CITY OF KELOWNA

MEMORANDUM

APPLICATION NO. OCP07-0028
Z07-0085

PURPOSE: TO AMEND THE OFFICIAL COMMUNITY PLAN FUTURE LAND USE DESIGNATION FROM SINGLE/TWO FAMILY TO LOW DENSITY MULTIPLE UNIT RESIDENTIAL AND TO REZONE THE SUBJECT PROPERTIES FROM RU1 – LARGE LOT HOUSING TO RM3 – LOW DENSITY MULTIPLE HOUSING. THE APPLICANT INTENDS TO CONSTRUCT A 65 UNIT RESIDENTIAL TOWNHOME DEVELOPMENT.

Conceptual Landscape Plan

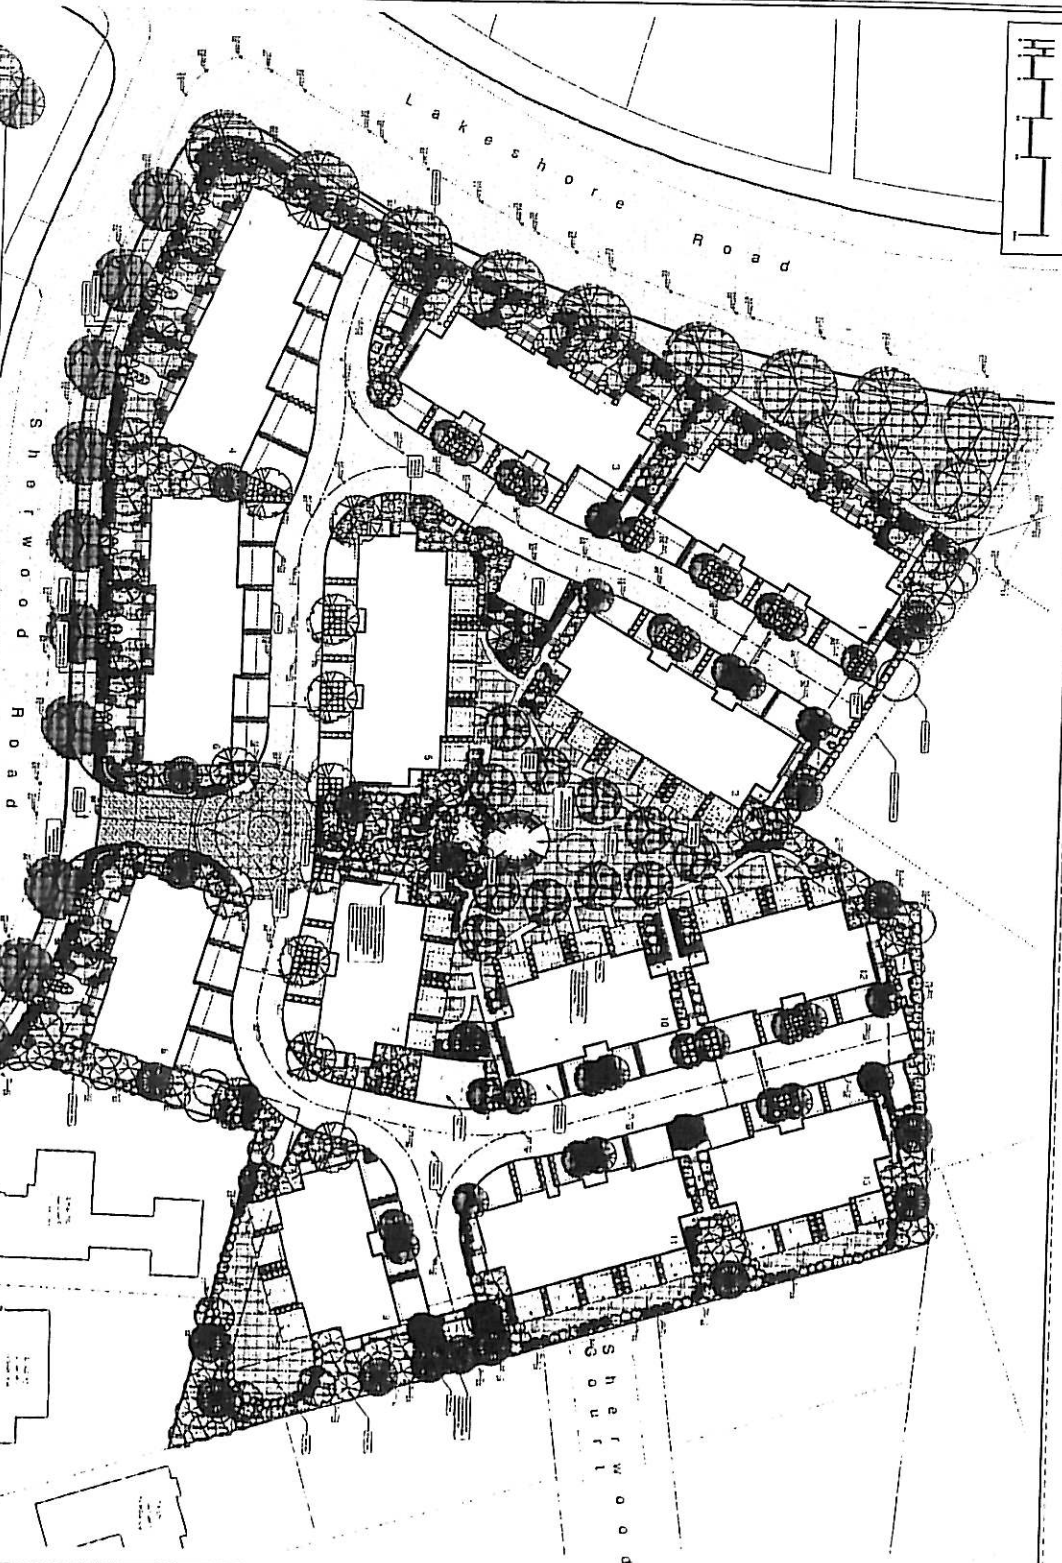
Detailed drawings are required showing article 3.2.5.6, Access Route Design, of the BC Building Code is met. No parking signs are required on both sides of the street as per article 2.5.1.5 of the BC Fire Code. Fire department access, fire flows, and hydrants as

Site plan does not appear to meet fire fighting requirements, turnarounds required on roads.
